Re: Variance Request 1342
Project Number PZX-22-00031

Be it known that my wife and I are strongly opposed to the variance request # 1342 at 2622 Rimrock Road; as are the majority of the surrounding neighbors.

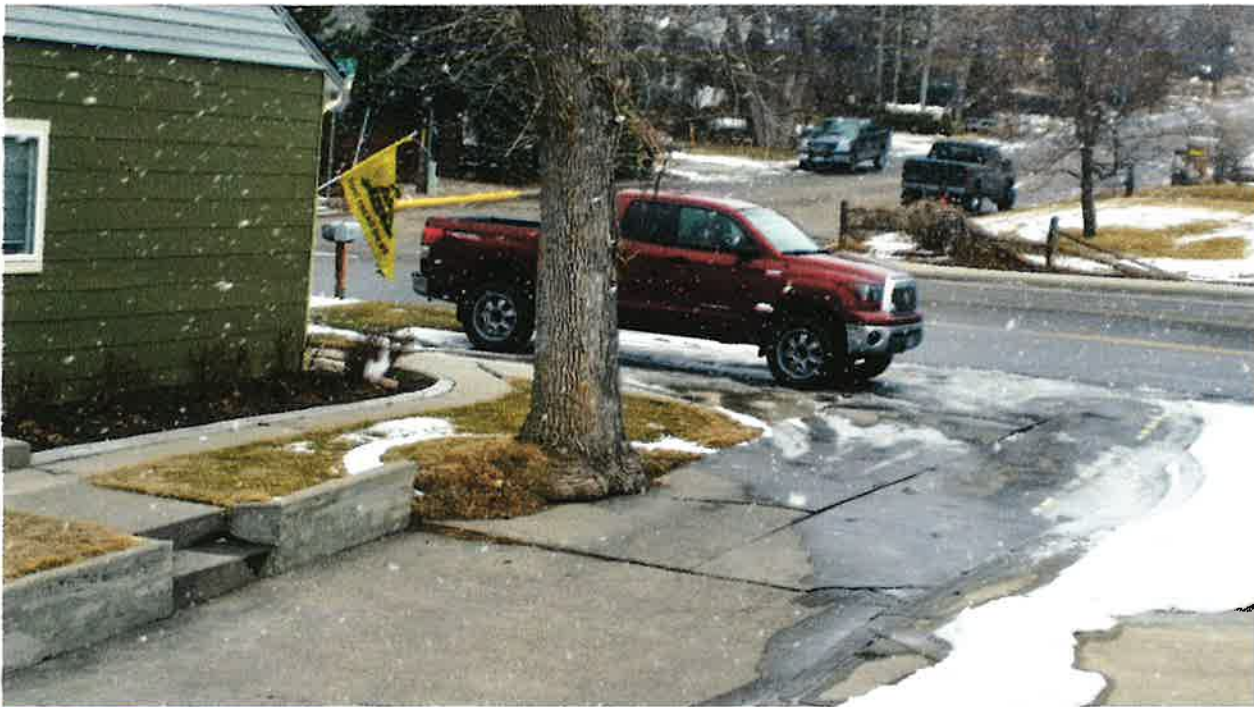
NARROW DRIVEWAY there is only 10 foot of space between the base of the ash tree trunk and the property line. Removing the tree would only add 2 feet (totaling 12') until the vertical cement is an obstruction that will limit the driveway width.

A LARGE SAFETY ISSUE surrounding the existing narrow driveway is the additional traffic they propose to push through in order to reach Rimrock Road. This congestion may also lead to conflicts between renters seeking to "get ahead" of other renters while exiting or entering the property. The driveway is not a shared driveway.

NOTE: this lot has eighty four and a half Ft (84.5') of street frontage THAT is a whopping 45.5' SHORTFALL. How do they envision having room for three (3) parked vehicles on the east side beside the existing house? **NOTE:** There may be space for two (2) vehicles to park in front of the North East corner of the house (where only one (1) can barely park now) **ONLY IF the cement pad is widened and lengthened.** BUT that will place one of the vehicles **TOO CLOSE to the street, which is also against city code!!**

The present garage is a **LARGE oversized single car garage** with an attached good sized shop and an electric garage door opener. They presently park their "modern" SUV in it.
